**MULTISITE ROOFING 2019**  
**Sheldon High School**  
**South Eugene High School**  
**Kennedy Middle School**  
**C.I.P. No. 420.780.209**

**ROBERTSON/SHERWOOD/ARCHITECTS pc**  
**132 E. Broadway - Suite 540**  
**Eugene, Oregon**  
**Project No. 1901**

This Addendum forms a part of the Contract Documents and modifies the original Bid Documents dated March 20, 2019 as noted below. Acknowledge receipt of this Addendum in the space provided on the Bid Form. Failure to do so may subject Bidder to disqualification.

**A1 201** SOUTH EUGENE HIGH SCHOOL SCIENCE WING ROOF PLAN  
1" = 10'-0"

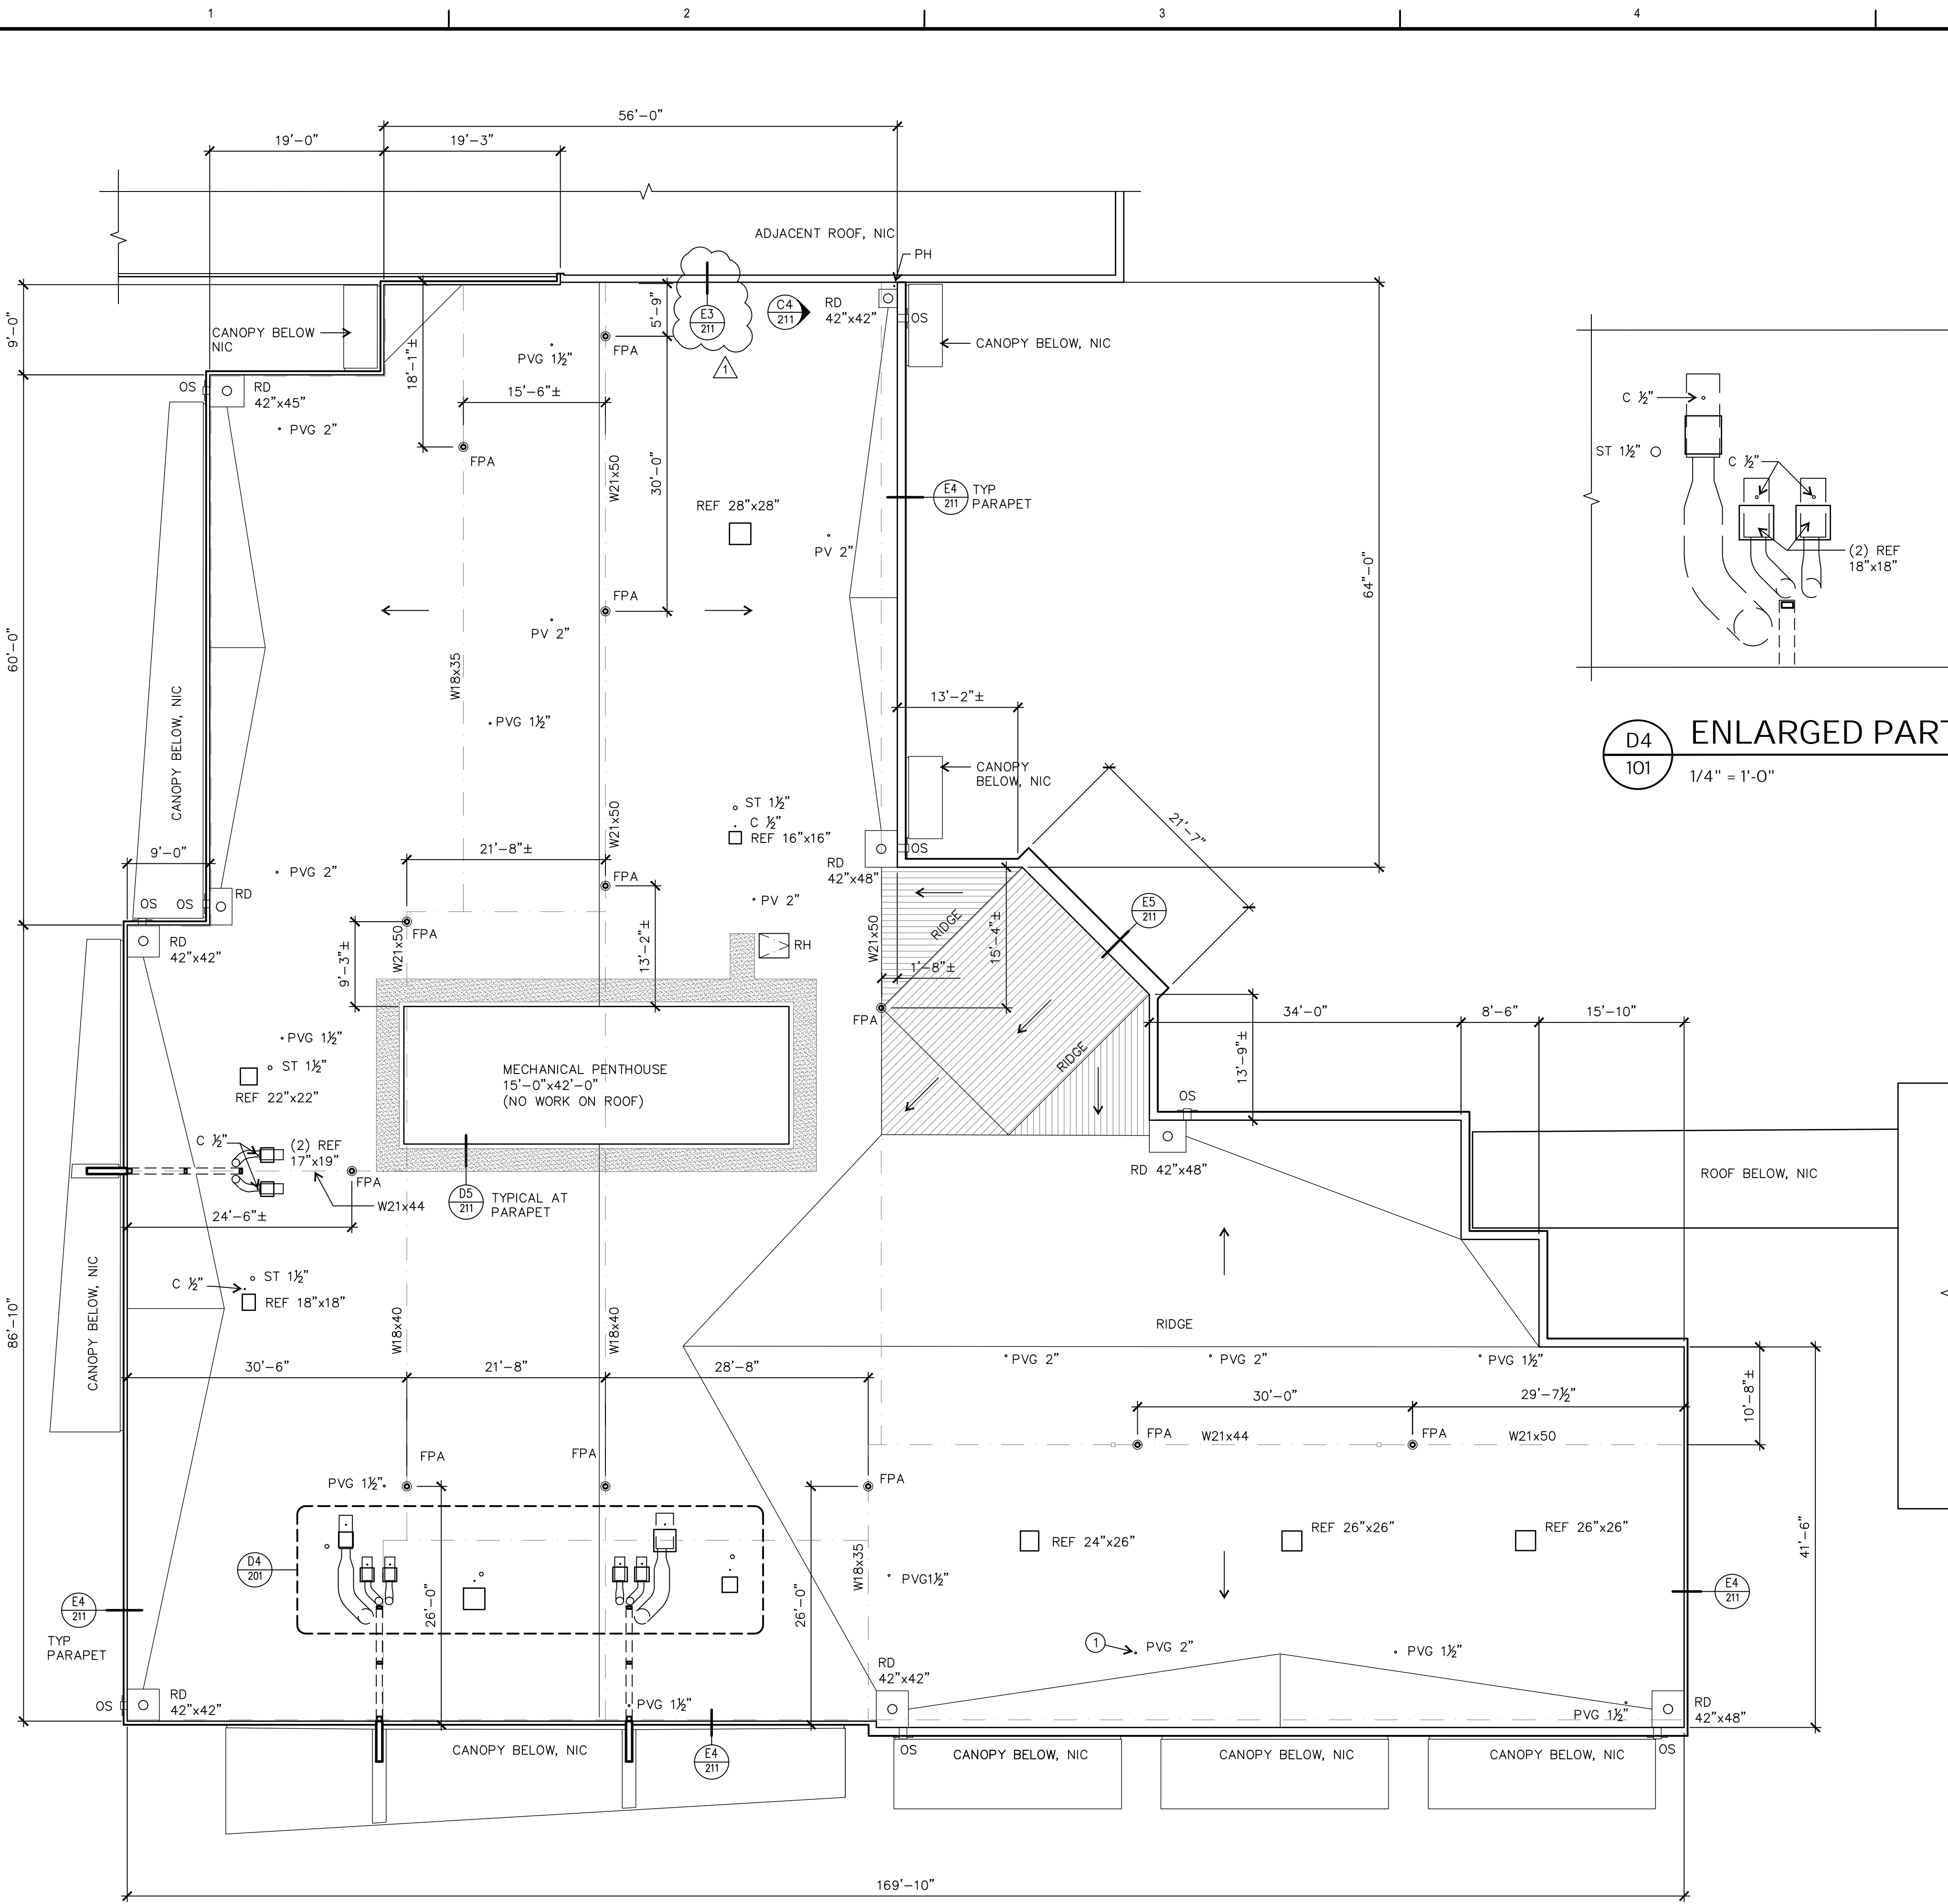
- A. Replace Drawing Sheet 201 with new Drawing Sheet 201 attached to this addendum.  
Clarification: Drawing is revised as follows:

- i) Scale of roof plan changed from 1/16" = 1'-0" to 1" = 10'-0"
- ii) Detail reference at north roof edge changed from "E4/211" to "E3/211".
- iii) Note added indicating that existing crickets were formed with tapered insulation.

**E4**  
211  
TYP ROOF AT PARAPET  
1-1/2" = 1'-0"

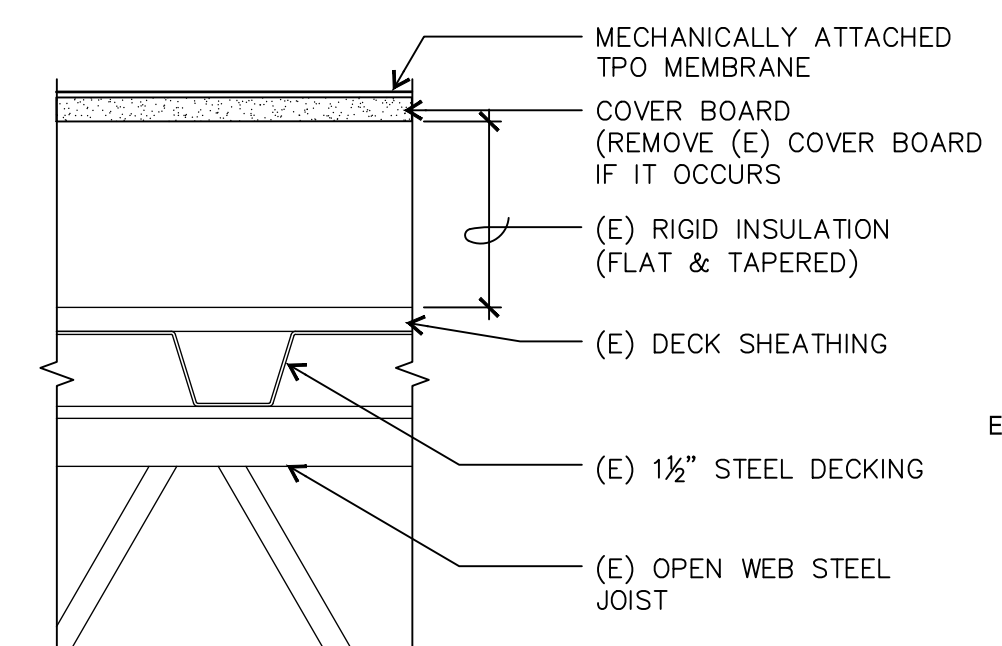
- A. Replace Drawing Sheet 211 with new Drawing Sheet 211 attached to this addendum.  
Clarification: Drawing is revised as follows:

- i) Details D4 and E3 are added.
- ii) Details E4 and E5 are modified to include termination bars and new counterflashing.
